FORMER ELEMENTARY SITE PARK PLAN **CITY OF DETROIT, OREGON**

SEPTEMBER, 2013

Community
Planning
Workshop

Figure 12.2. Organic concept poster

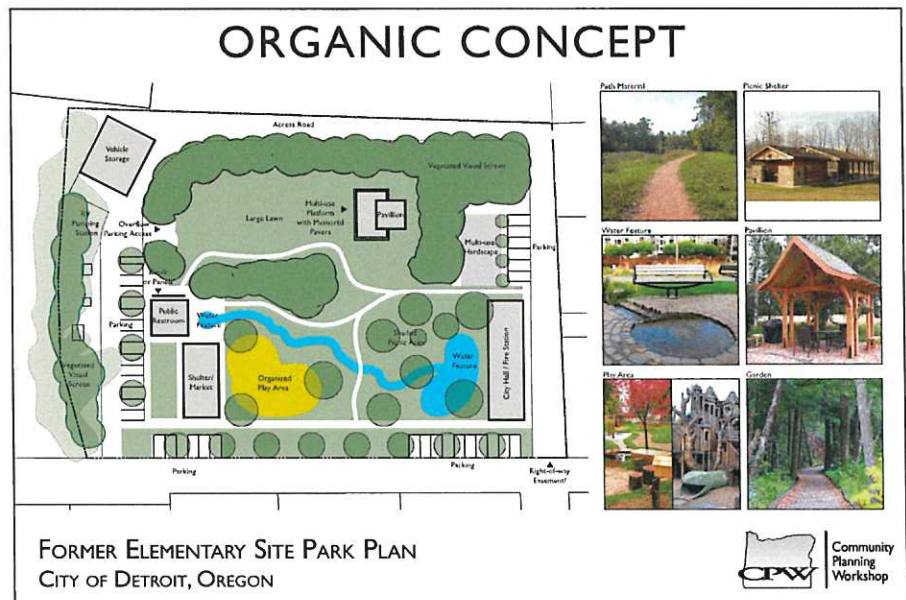
- Organic play area building is scary!
- Plaza is too urban feeling.
- Who manages the RV pumping station? Do we need it?
- No RV dumping, please.
- Need electricity in pavilion.
- No sand in the play area—becomes kitty litter!
- Wood playground would not hold up to weather.
- Not the stone pavilion.

- Fire station should be oriented along the street or at a diagonal.
- Drive-through design for the fire station.
- Would like a two-story firehall. (I WANT A FIRE POLE.)
- Pavilion should be in a more intimate area, like the shaded picnic area.
- Pavilions don't work for stage areas—these two uses need to be separated to provide for good sound at events.
- Shute Park in Hillsboro has a good precedent for a working permanent stage area.

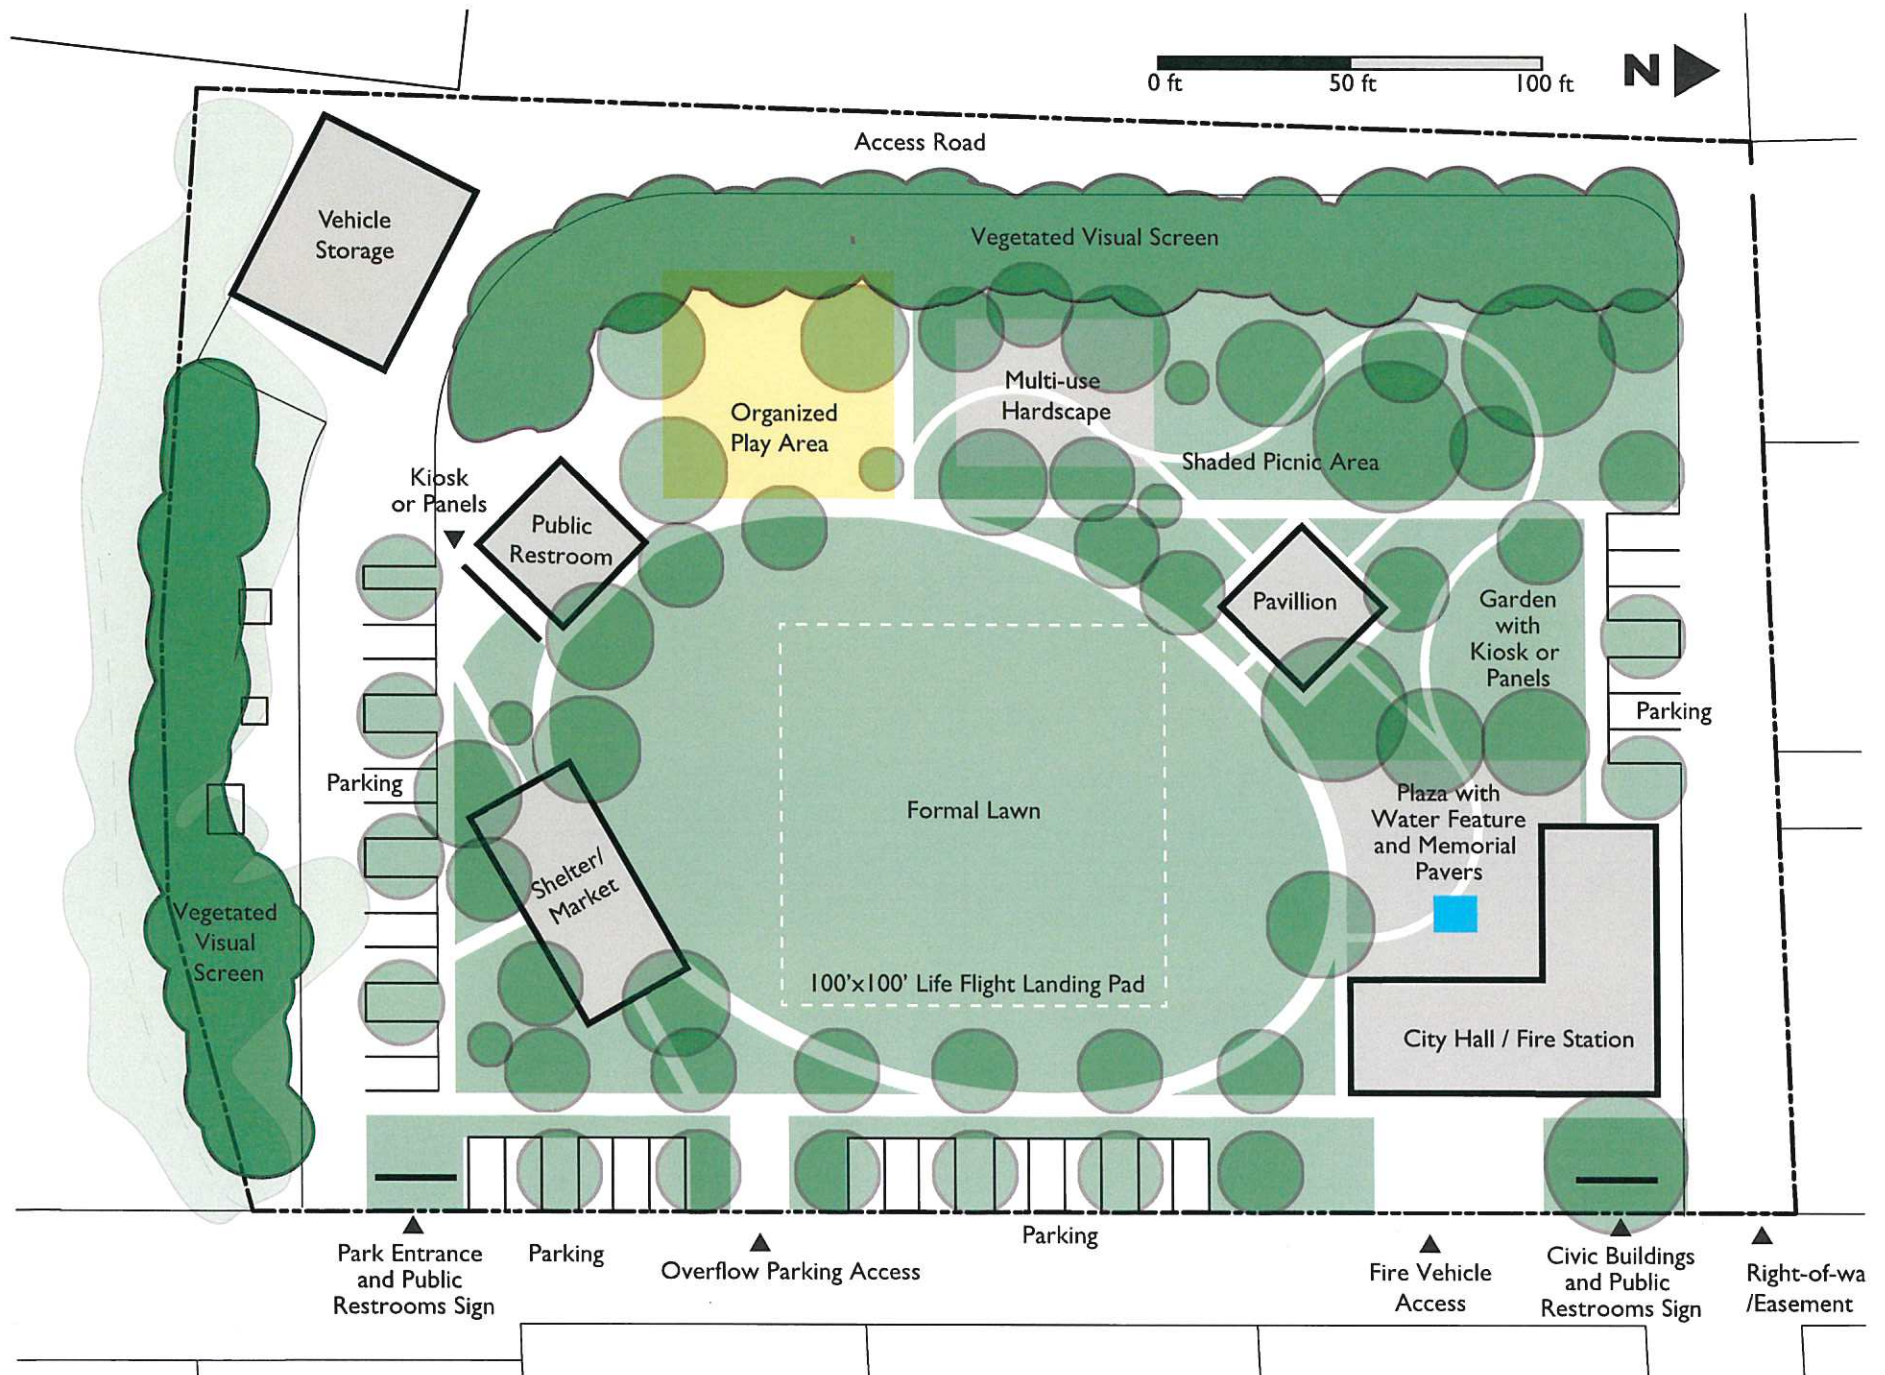
- The multi-use hardscape element should include a basketball hoop.
- There should not be a separate skate-park element but the plaza should be designed to accommodate, not repel, skateboard users.
- Electrical outlets should be available throughout the site to accommodate community events.
- The location of the public restrooms should be moved to the southeast corner to most easily accommodate the needs of motorists. The location should be swapped with the location of the picnic/market shelter.
